Architect's Supplemental Instructions Addendum

Project: Samish Xwch'ángteng Development on 34th Street
Anacortes, WA

Addendum/ASI No.: Addendum 03
Date of Issuance: May 23th, 2022

SHEET
E-102
COMMUNITY CENTER
POWER PLANS

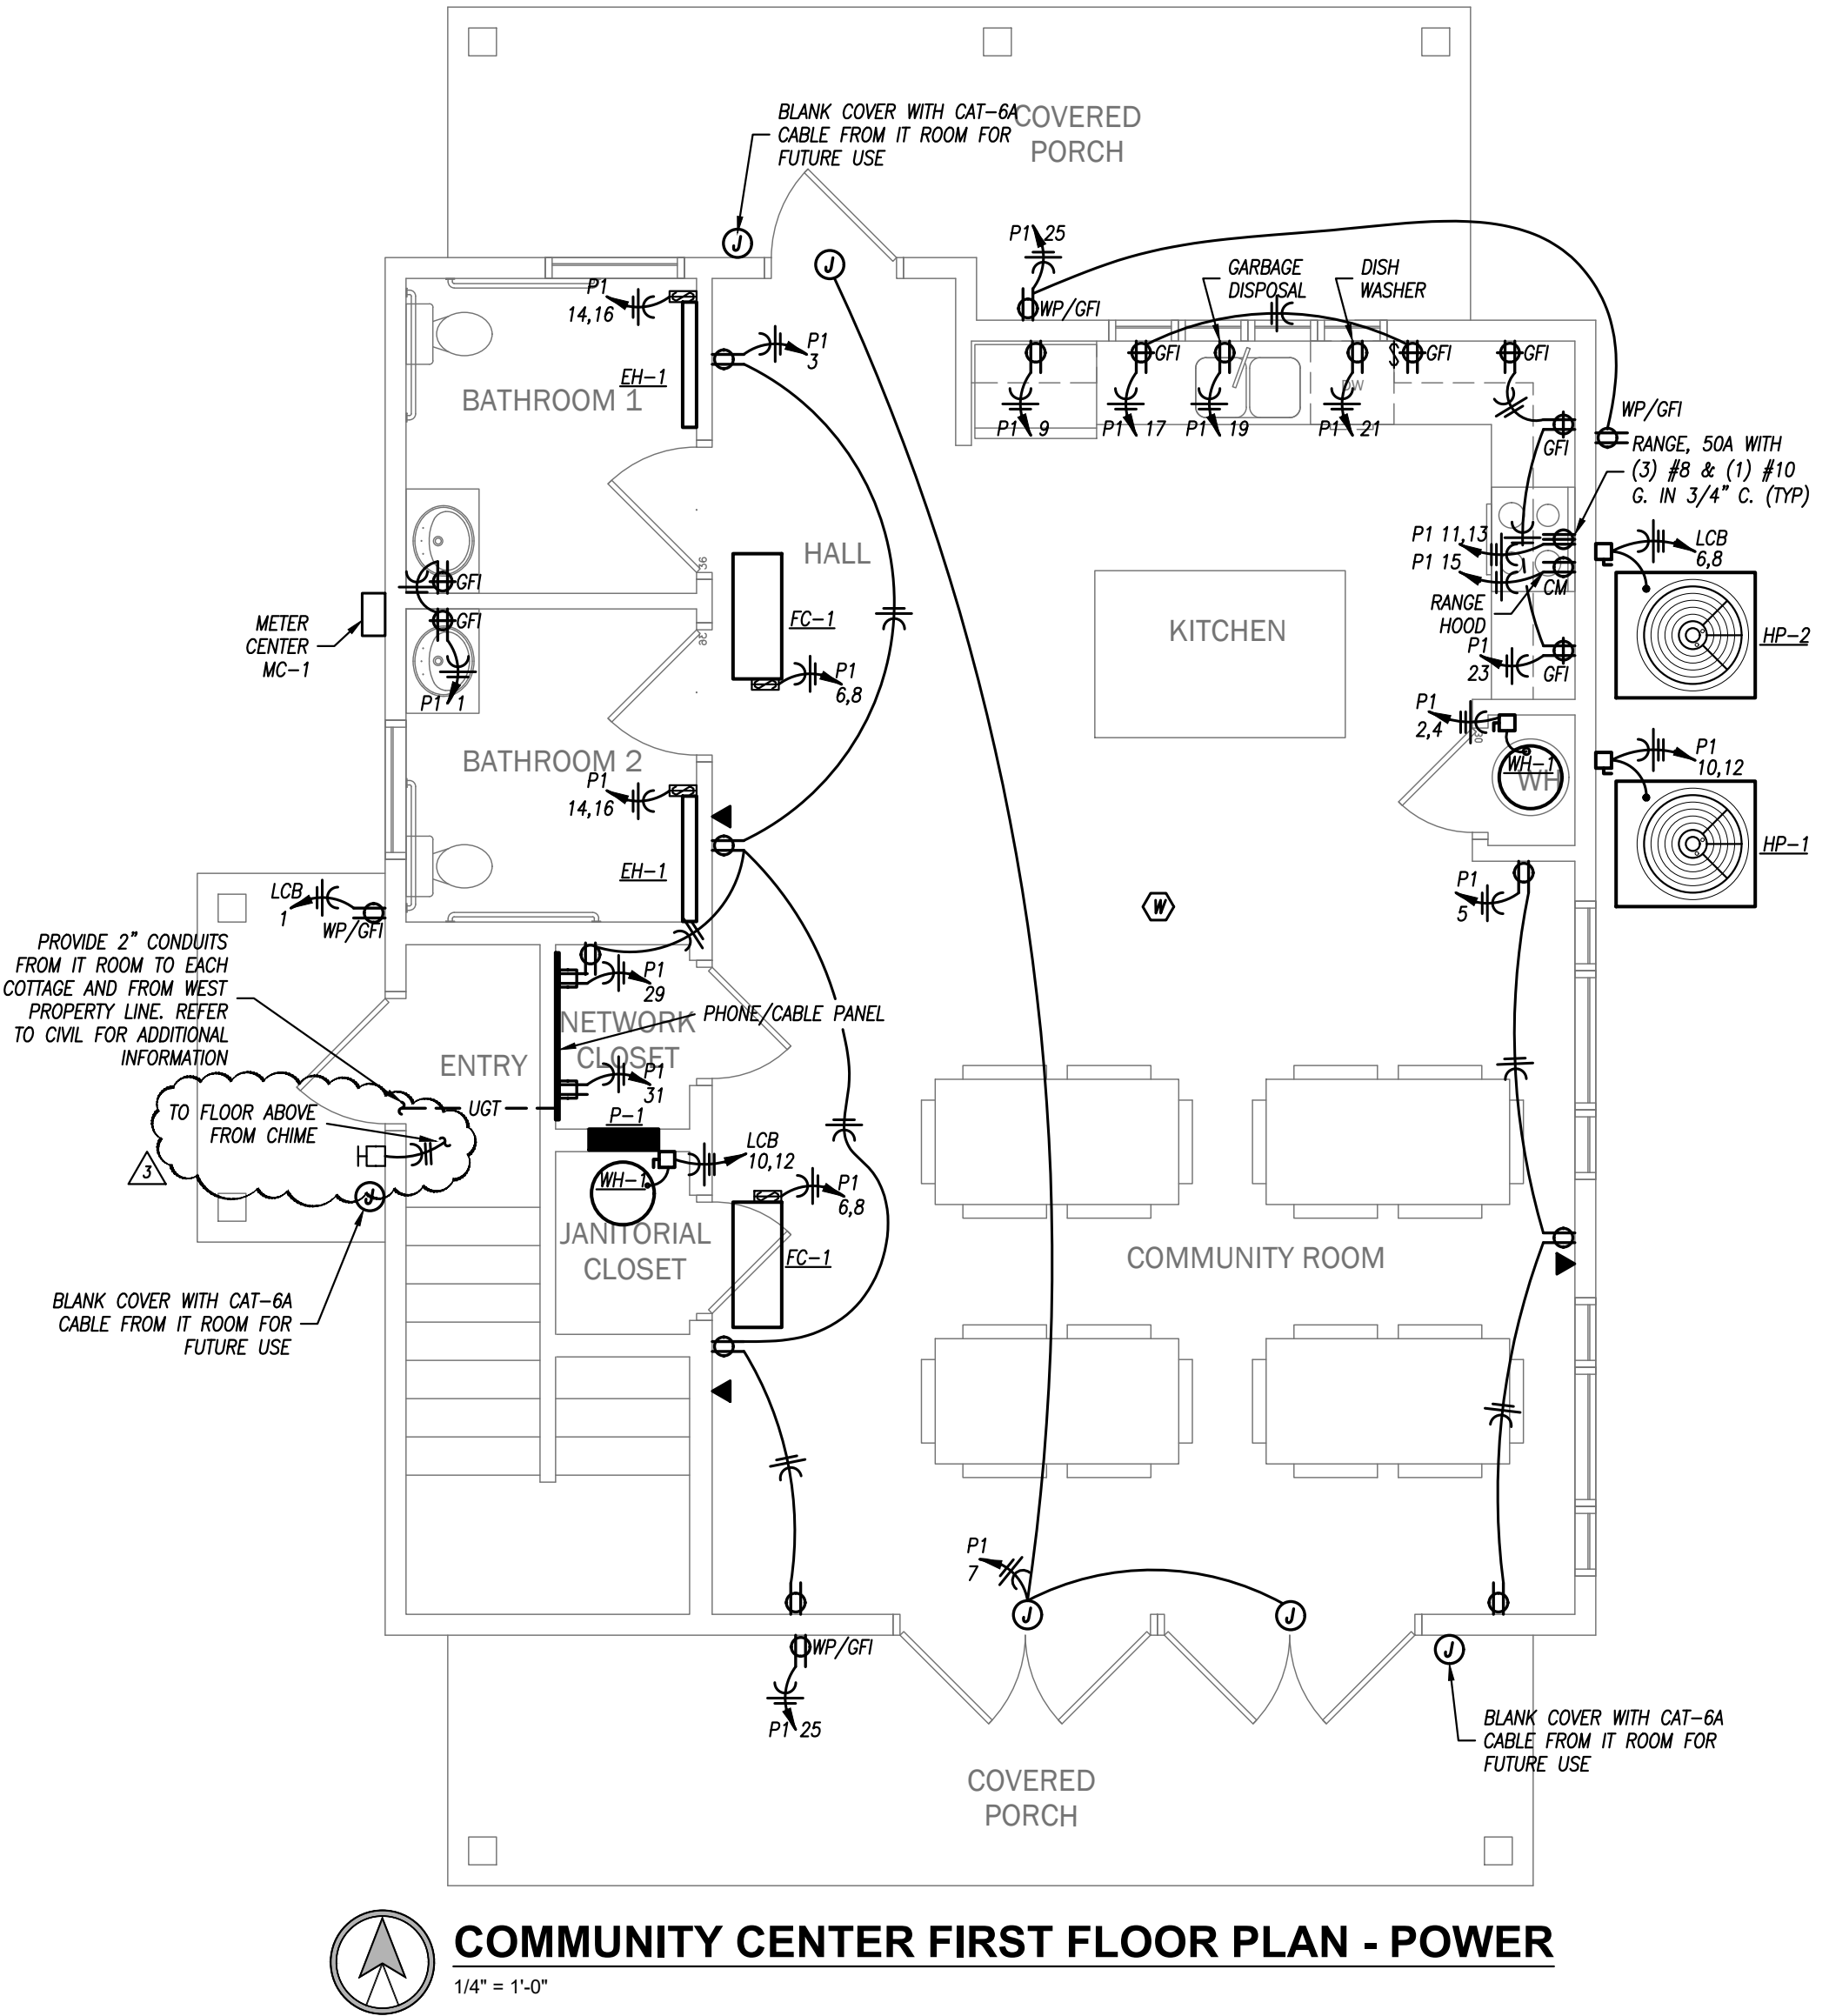
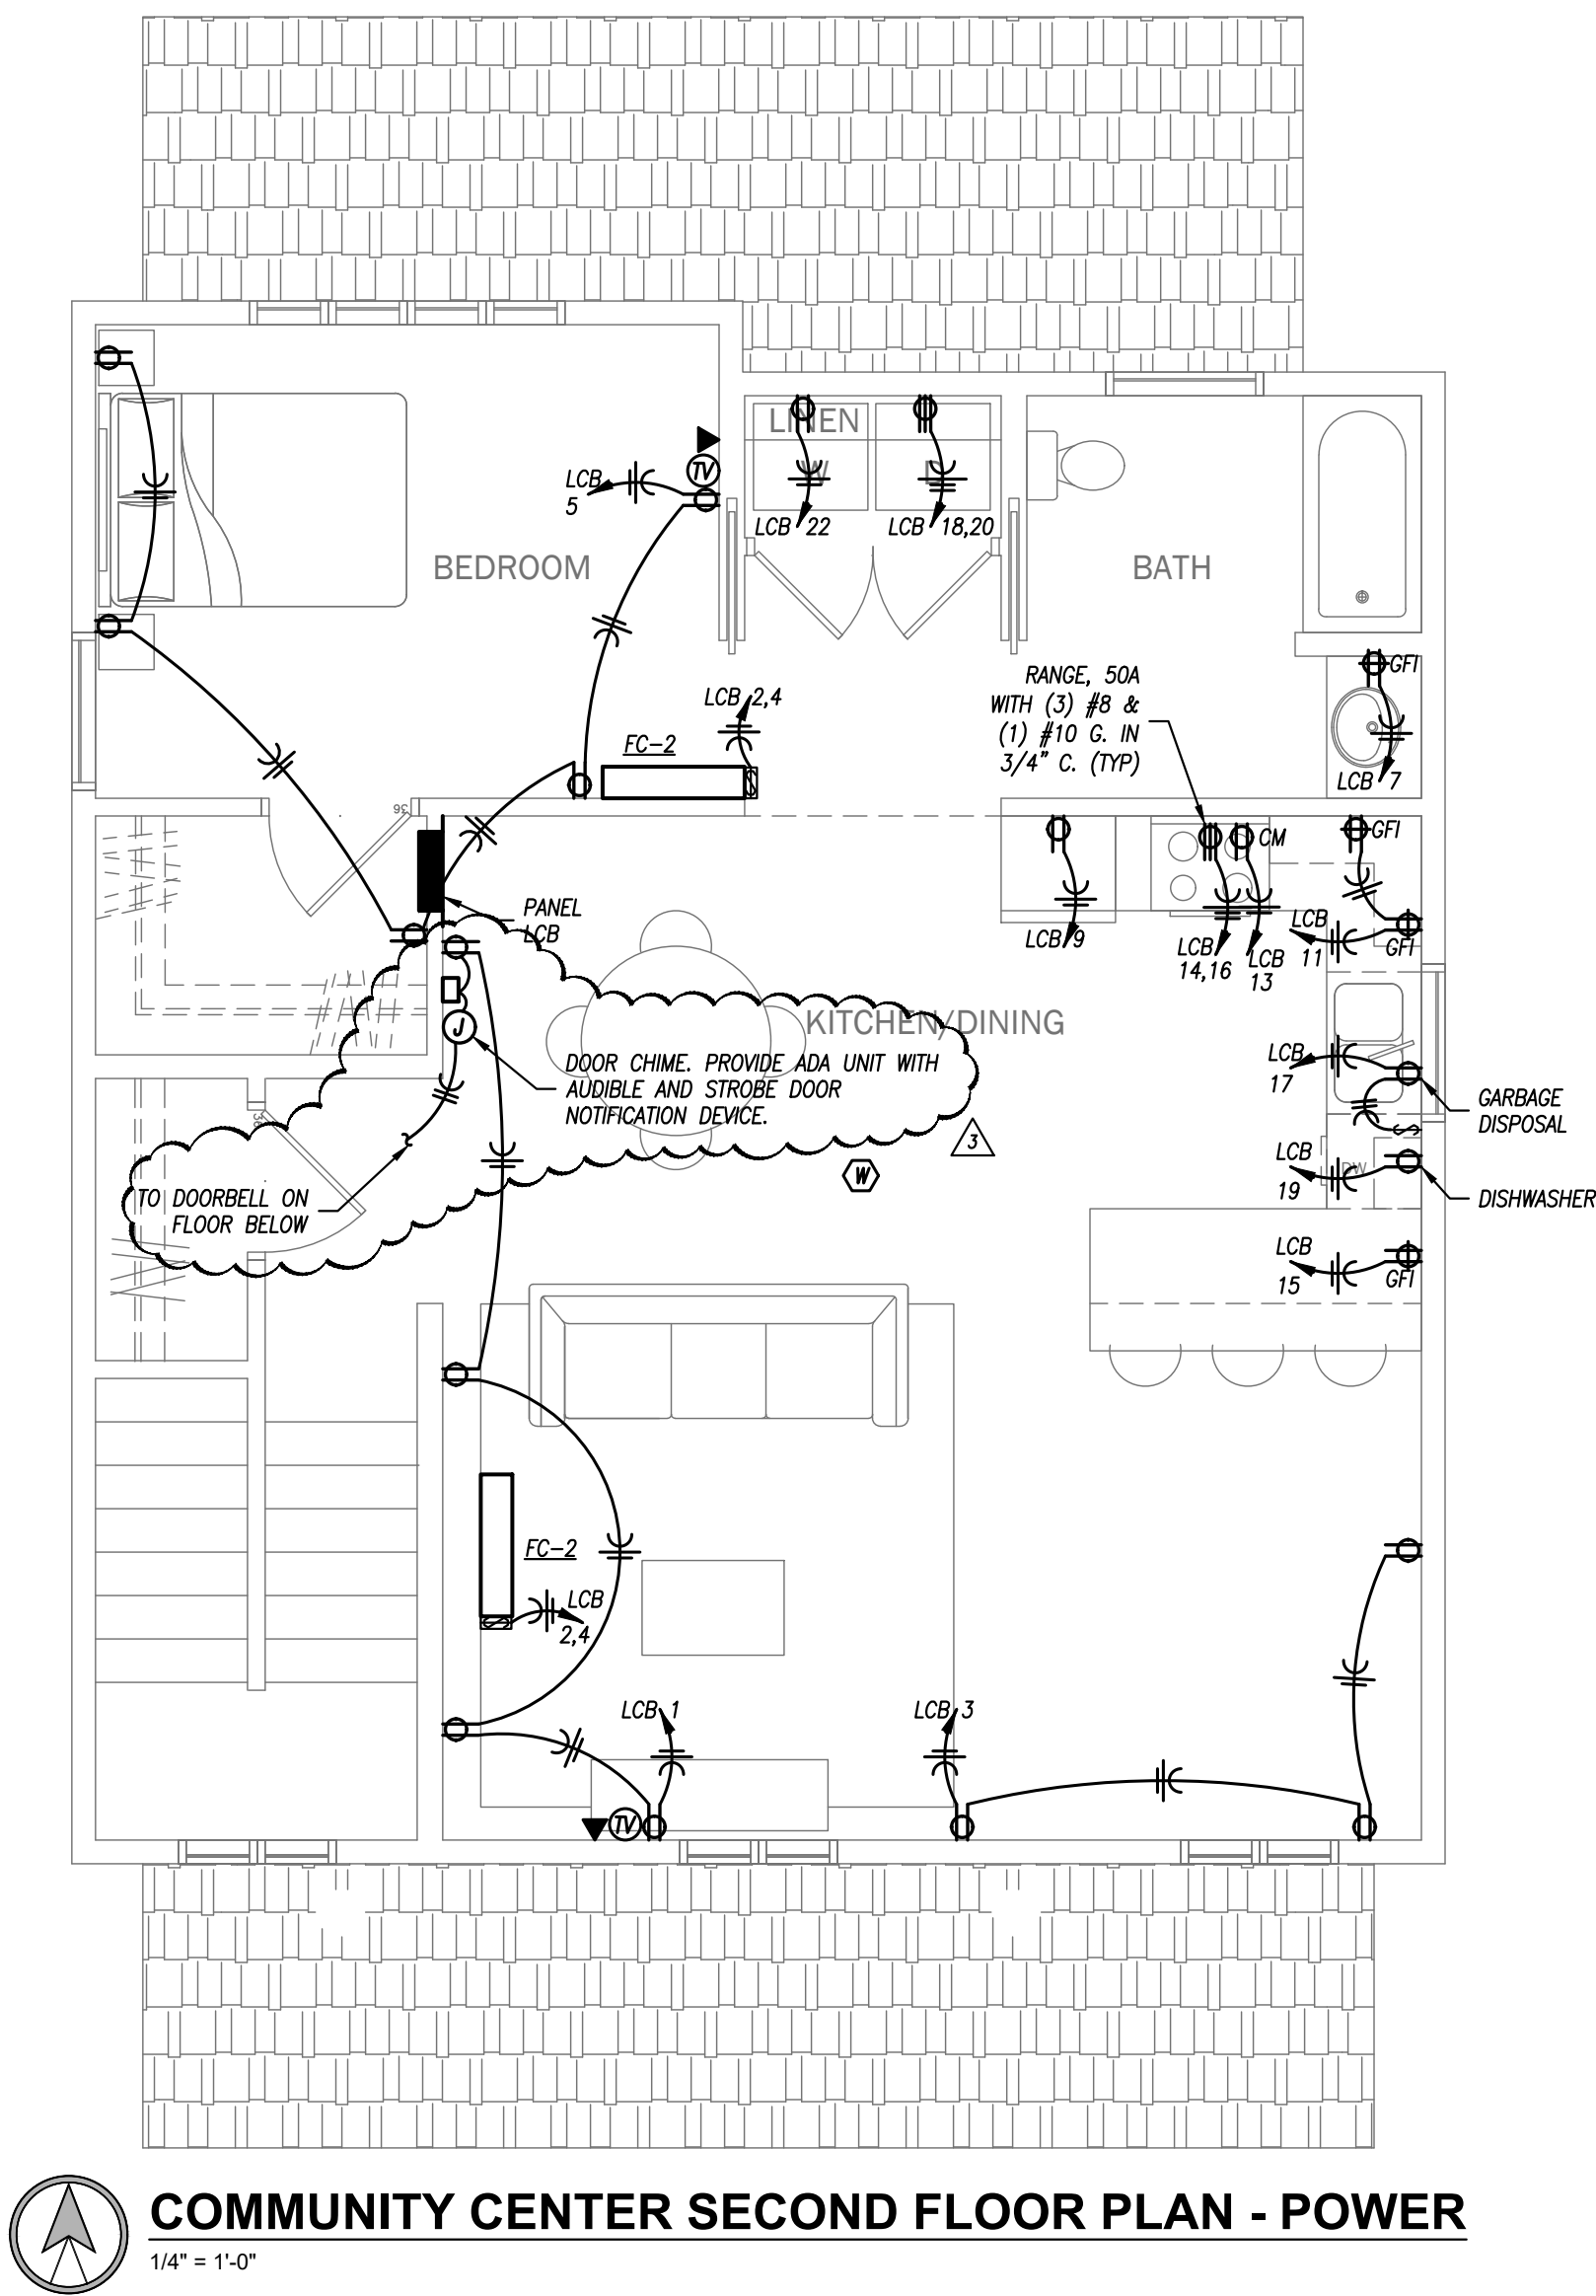
20. Please define what the sensory unit requires or where we can find the information. [It is referenced in the building code 2009 ICC A117.1 Section 1006. Smoke Alarm information is noted Sheet E-401 Section 16600 – Smoke Alarm D. See attached revised sheet E-101 & E-102 Door chime & Strobe](#)

10. Sheet M-101 **ADD EXHAUST FAN**
11. Sheet M-102 **ADD EXHAUST FAN**
12. Sheet M-201 **ADD EXHAUST FAN**
13. Sheet E-101 **ADD DOOR CHIME**
14. Sheet E-102 **ADD DOOR CHIME**

E-501
LIGHTING SCHEDULES
& DETAILS

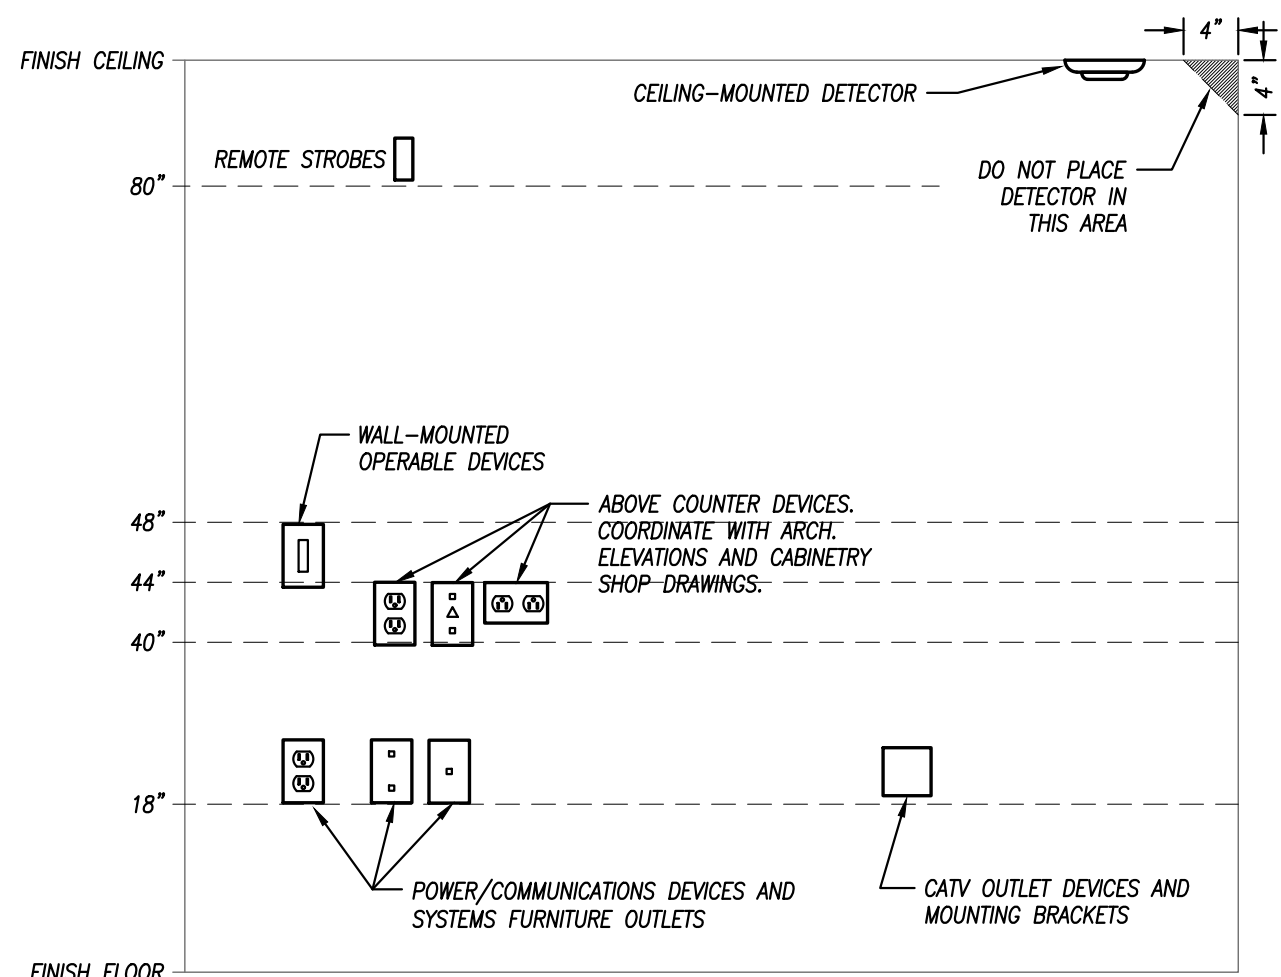
16. Where is page 58 ES01, Lighting Schedules and details? [See attached revised sheet E501](#)
17. Interior Door schedule: Door 203 the pantry and common building water heater closet, flush panel do not match the other 6 panel interior doors, is this intentional? [See attached revised sheet A404](#)

15. Sheet E-301 **ADD EXHAUST FAN**
16. Sheet E-302 **ADD EXHAUST FAN**
17. Sheet E-501 **Sheet number changed from E-401**
